PCD FILE NO. PPR-21-024

STANDARD NOTES FOR EL PASO COUNTY GRADING AND EROSION CONTROL PLANS

DRAWN BY: O.E. WATTS	APPROVED BY:	REVISIONS 3-16-21 REVISED BUILDINGS DEW	PROJECT 10659 MALTESE POINT LOT 11, ROLLING THUNDER BUSINESS PARK EL PASO COUNTY	SHT. NO. 2 OF 4
DATE: 4-2-21	PROJ. NO.:	9-27-21 REVISED PER COUNTY REVIEW COMMENTS DEW		
DWG. NO.: 20-5509-07	DWG.:	12-30-21 REVISED PER COUNTY REVIEW COMMENTS DEW		
SURVEYED BY: DEW, ESW, 6-26-19, 9-24-20

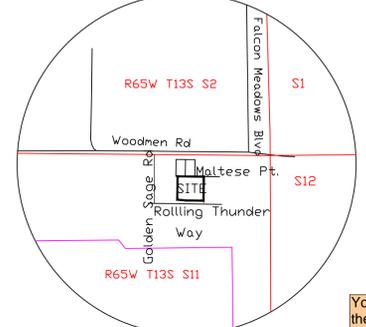
provide location and details for spill curb and carry curb as discussed during our April 26 meeting.

This area should be cut. I am still unable to identify the cut/fill areas. Shading the cut/fill areas may work best, visually.

Please add Silt Fence line from V3

doesn't match UD-BMP calcs

provide detail and dimensions of inlet, riprap rundown, and 12\"/>

713SF in accordance with Drainage Report, -1100SF according to the UD-BMP for PLD

During our April 26 meeting we discussed adding a cross pan here to keep all SW onsite and directed towards the SFB.

You agreed to change these to "initial/interim" during our meeting on April 26

PLD POND DETAIL
NOT TO SCALE

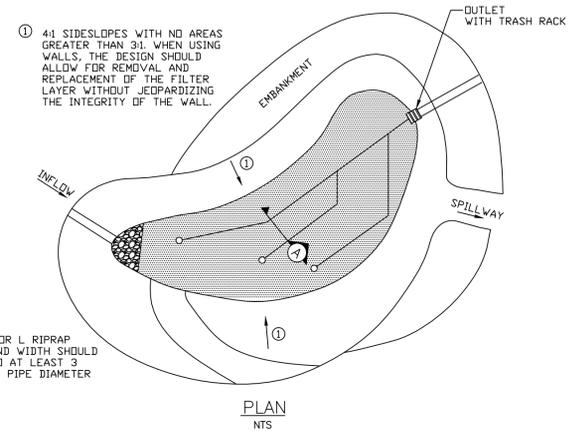
Provide orifice plate detail
Provide Spillway detail (i.e., how pond ties into sidewalk and erosion protection methods.)

FILTER TRENCH
NOT TO SCALE

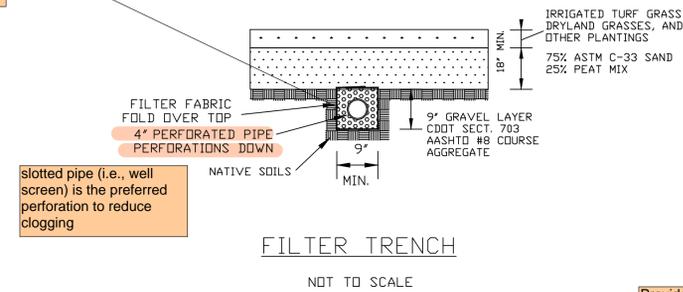
MHFD T-3 does not require filter fabric around the gravel layer. The County recommends removing this.

slotted pipe (i.e., well screen) is the preferred perforation to reduce clogging

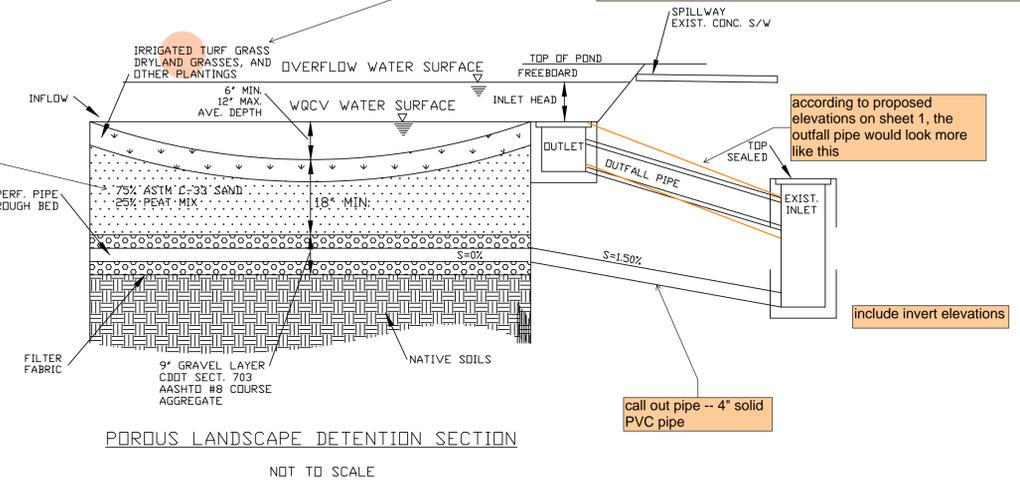
Provide seed mixture for PLD - MHFD recommends that the filter area be vegetated with drought tolerant species that thrive in sandy soils. Do not use conventional sod. Conventional sod is grown in clay soil that will seal the filter area, greatly reducing overall function of the BMP. (See MHFD Table B-6. Native Seed Mix for Rain Gardens)

MHFD recommends 85/15 for optimal filtering

according to proposed elevations on sheet 1, the outfall pipe would look more like this

call out pipe -- 4\"/>

include invert elevations
